SERVICE BULLETIN

ENGINE - HP TURBINE ROTOR AND STATOR ASSEMBLY - INTRODUCE A NEW STAGE 1 HP TURBINE AIR SEAL - CATEGORY CODE 8 - MOD.ENG-72-0194

V2500-ENG-72-0194

Location of the Stage 1 HPT Air Seal
Fig.1

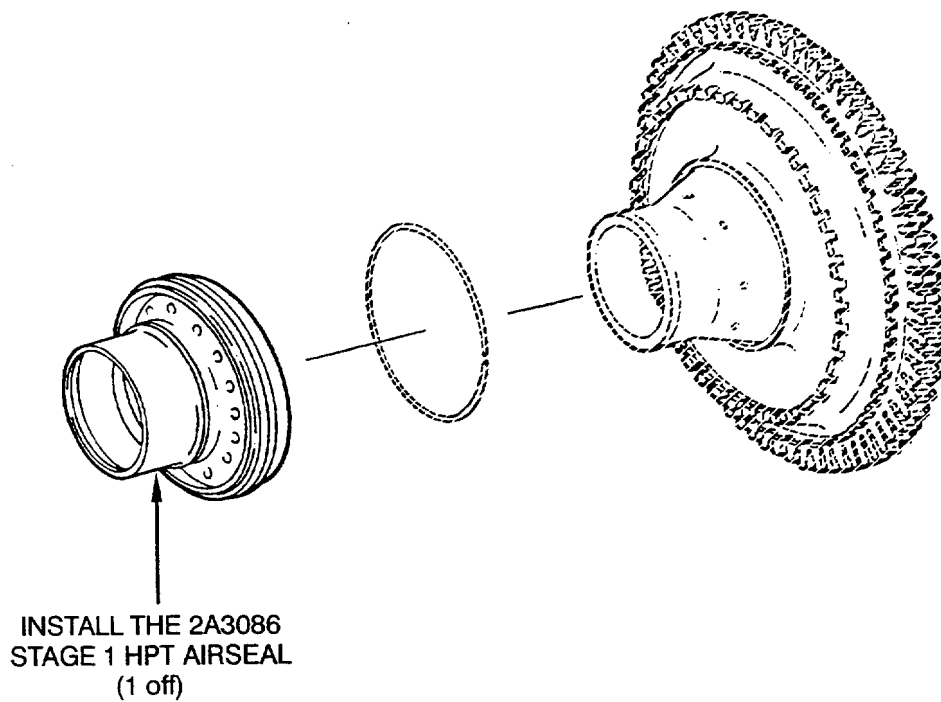
To provide a Stage 1 HPT Air Seal with features that let the unwanted oil drain more quickly. These features include: Scallop cuts and the removal of the dirt discourager rail.

- (1) Improve the features of the Stage 1 HPT Air Seal so that more of the unwanted oil will drain from the area between the air seal and the Stage 1 Hub.
- (2) For the effect on declared life, see Reference (5) or (6), Time Limits Manual, Chapter/Section 5-10-01, Group A Parts Lives.

- (1) Install the 2A3086 Stage 1 HPT Air Seal (1 off) by the approved procedure given in References (3) or (4), Chapter/Section 72-45-10 Assembly. See Figure 1.
- (2) Identify the new Stage 1 Turbine Rotor Assembly as 2A8921 by the procedure given in Reference (7), Chapter/Section 70-09-00, Marking of Parts.
 - (a) Use the vibration peen method.
 - (b) Mark the new part number adjacent to the old part number.

Location of the Stage 1 HPT Air Seal
Fig.2

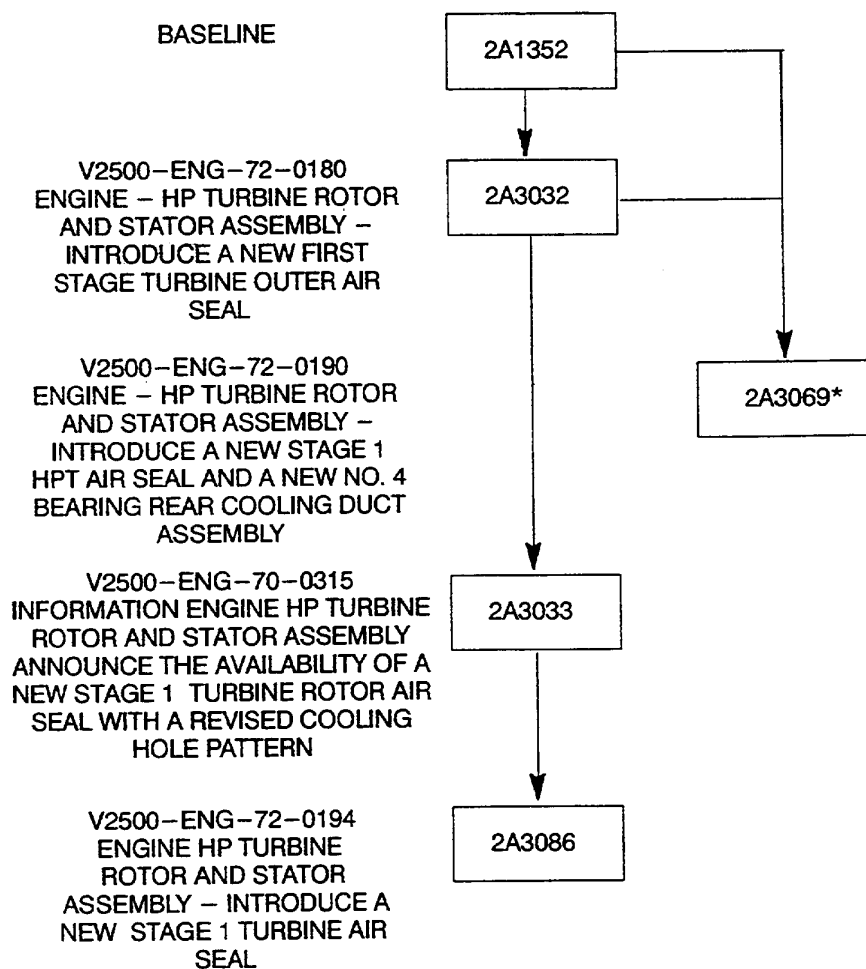
PART NUMBER CHANGE

*NOTE: THERE IS NO PROCEDURE TO ADVANCE THIS CONFIGURATION
